ADDENDUM NO. 1

March 21, 2025

**Ascension Catholic Secondary School Renovation
PROJECT NO. 24137
HOSSACK ARCHITECTURE**

Halton Catholic District School Board
Renovations to Ascension Catholic Elementary School
Hossack Architecture
Project No. 24137

DEMOLITION SECOND FLOOR PLAN

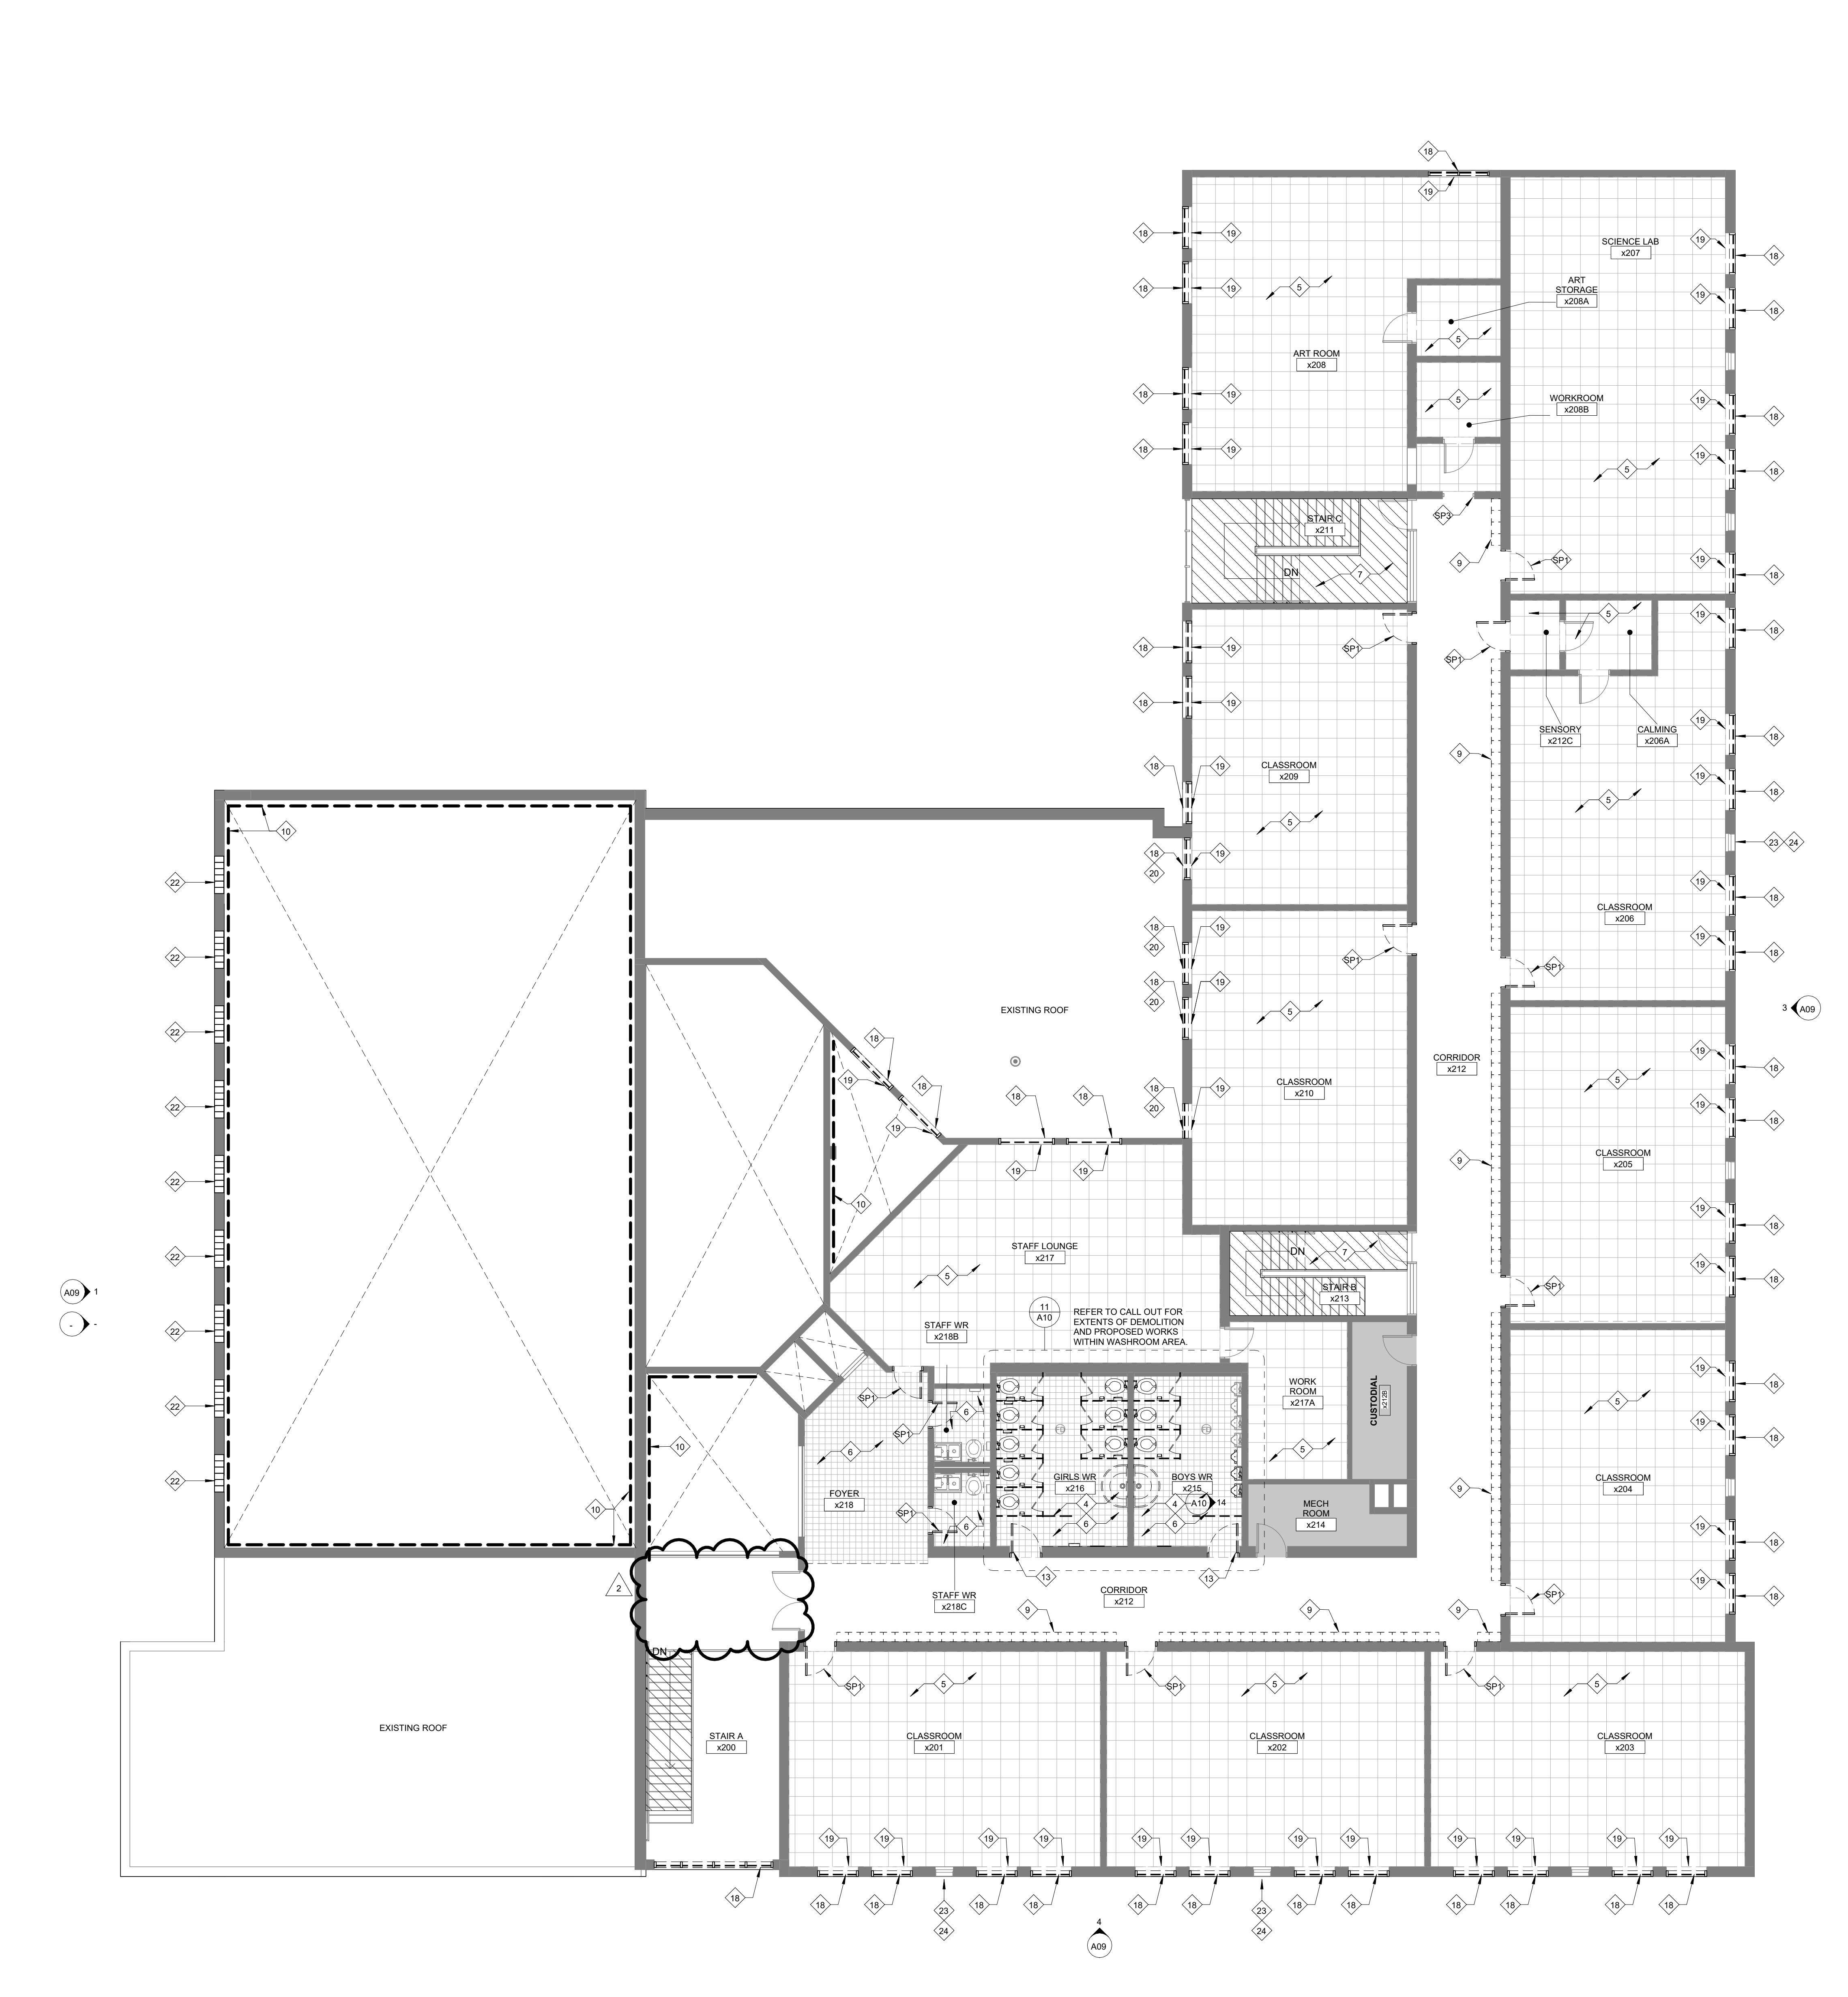
Item 7: Drawing A04 Demolition Second Floor Plan:

- .1 REVISE floor plan to show terrazzo to remain (not being removed) within Stair A.

PROPOSED SECOND FLOOR PLAN

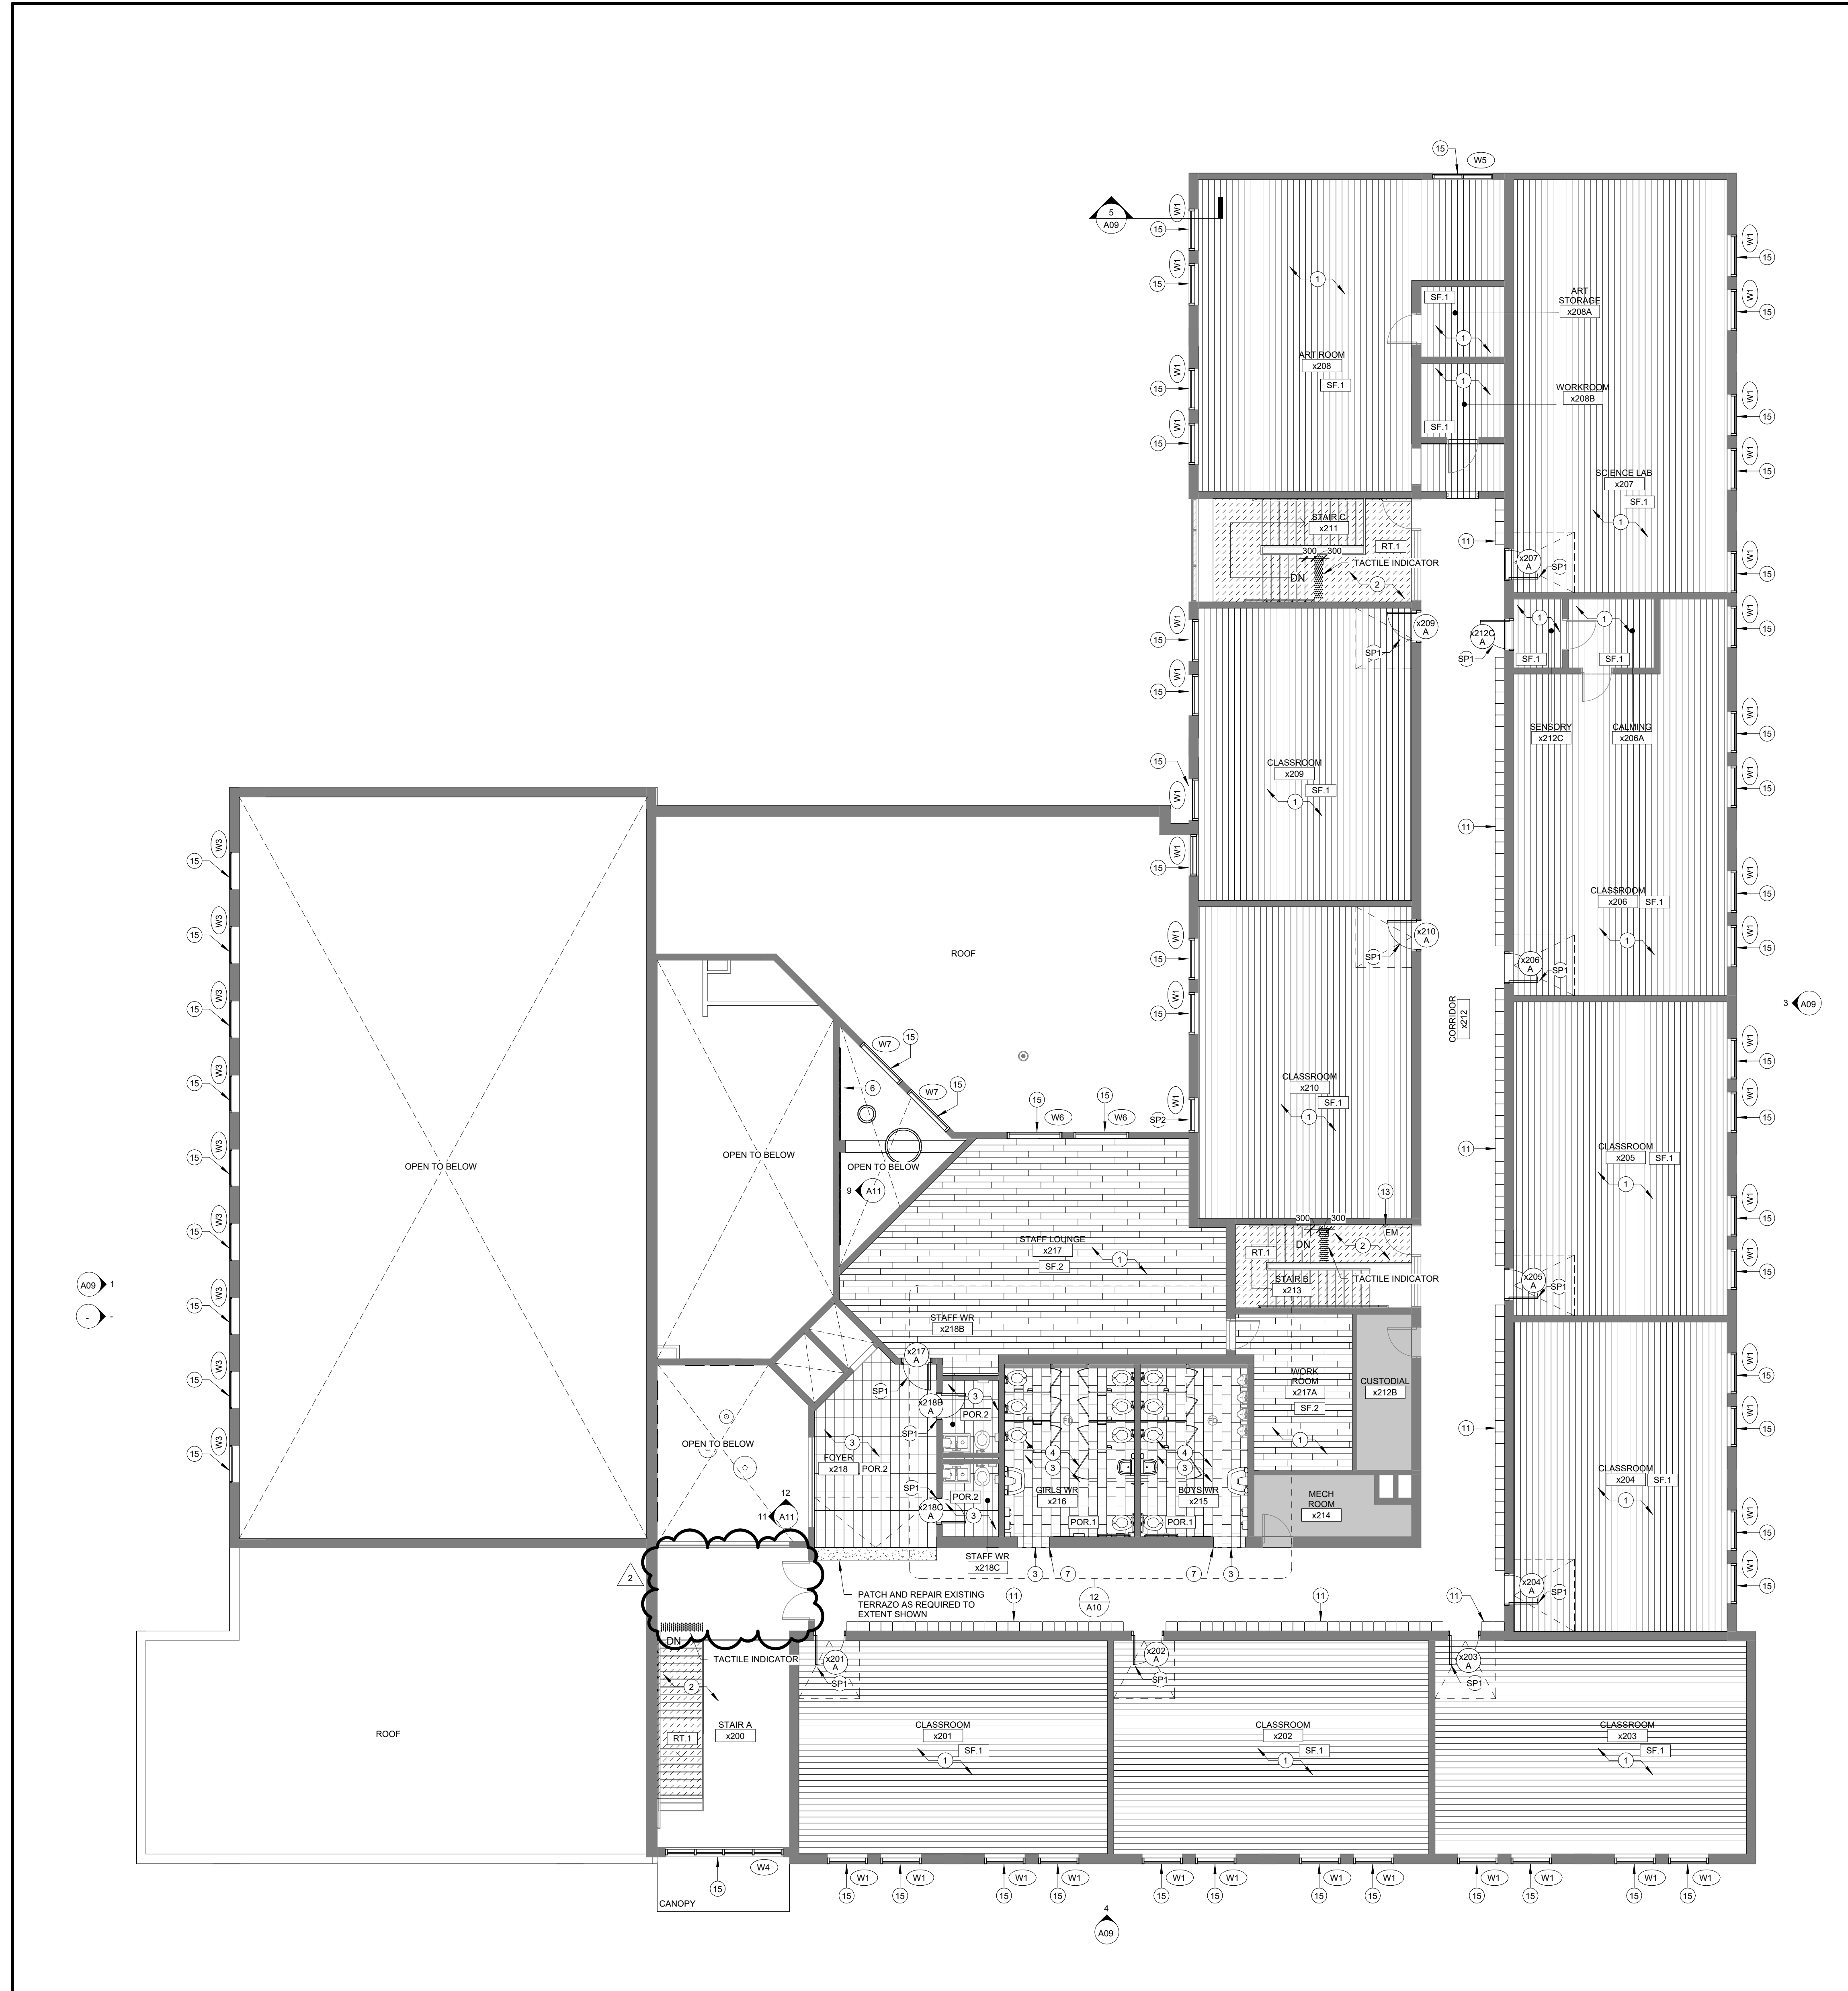
Item 8: Drawing A05 Proposed Second Floor Plan:

- .1 REVISE floor plan to show reduced extent of rubber tile being installed within Stair A.

DATE:	FEBRUARY 2025
SCALE:	1:110
DRAWN BY:	AS
CHECKED BY:	MA
DWG STATUS:	TENDER
PROJECT No.:	2025-476
DRAWING No.:	E3.0 -A-1
REVISION:

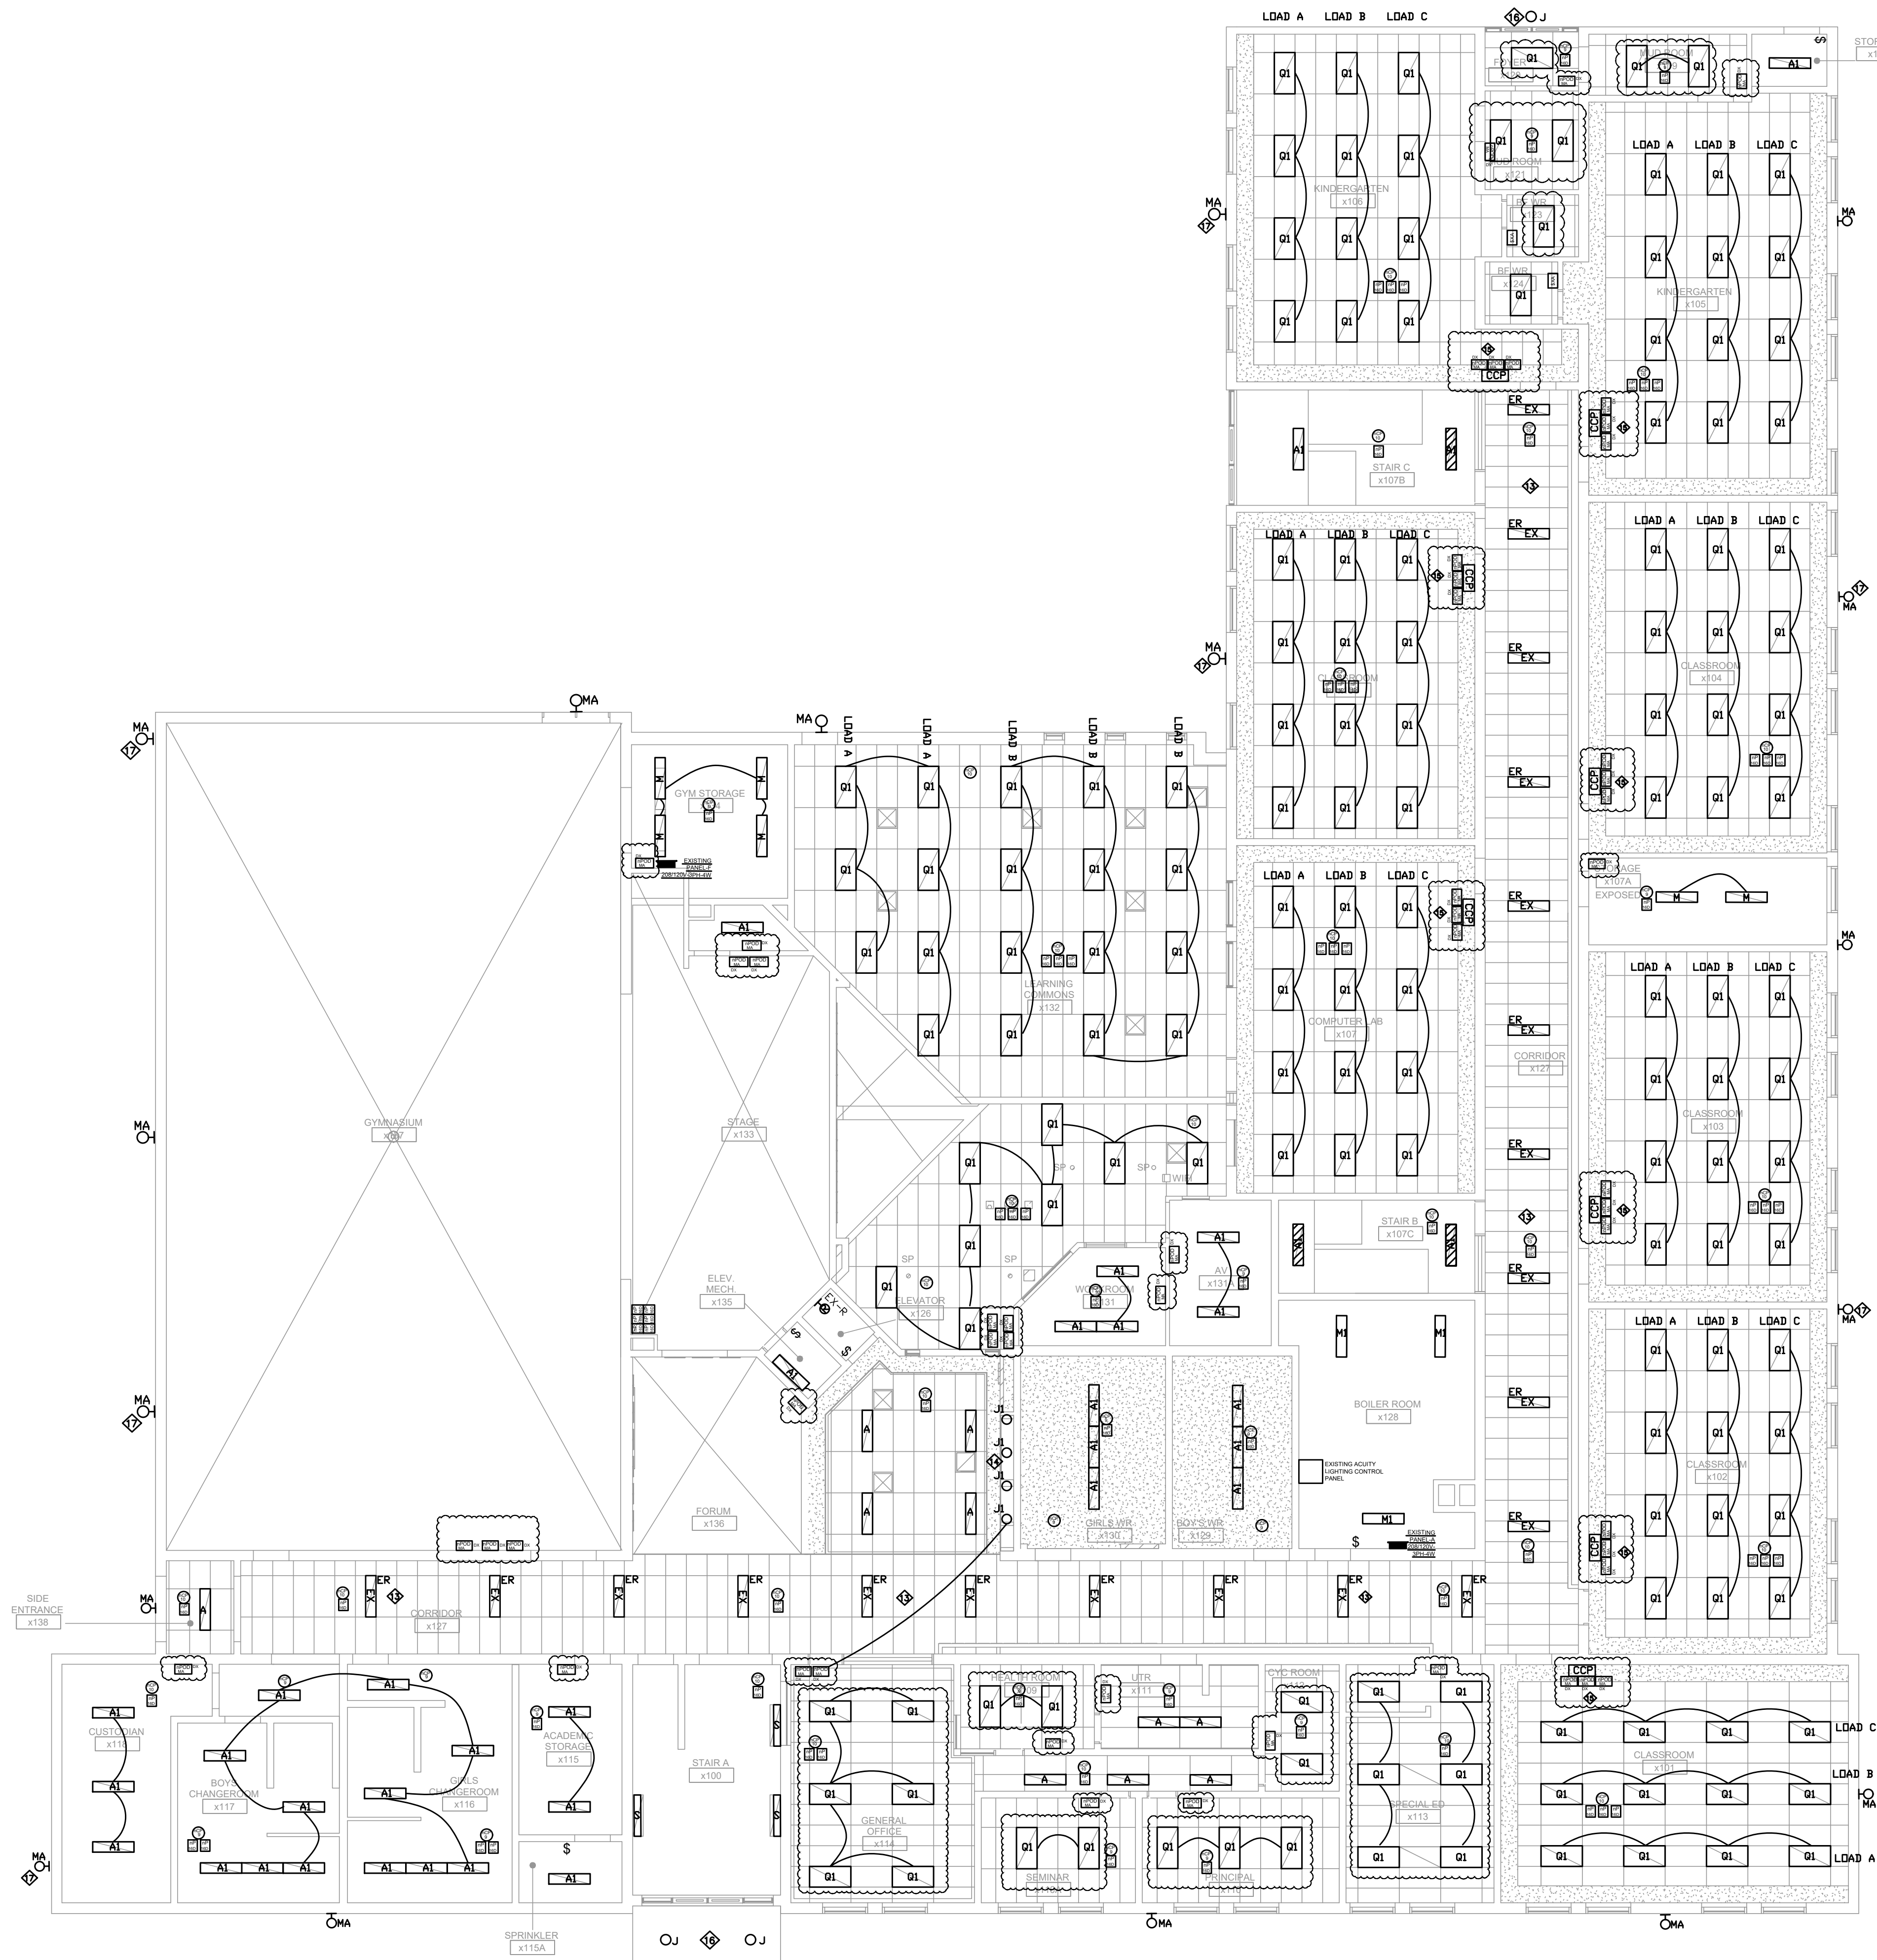
1. Replace/add the drawings with as under:
 1. Lighting fixtures by Peerless Electric shall be treated as equal.
 2. Find attached revised electrical drawing E1.0-A-1 with changes shown as clouded.
 3. Find attached revised electrical drawing E2.0-A-1 with changes shown as clouded.
 4. Find attached revised electrical drawing E2.1-A-1 with changes shown as clouded.
 5. Find attached revised electrical drawing E3.0-A-1 with changes shown as clouded.
 6. Find attached revised electrical drawing E3.1-A-1 with changes shown as clouded.
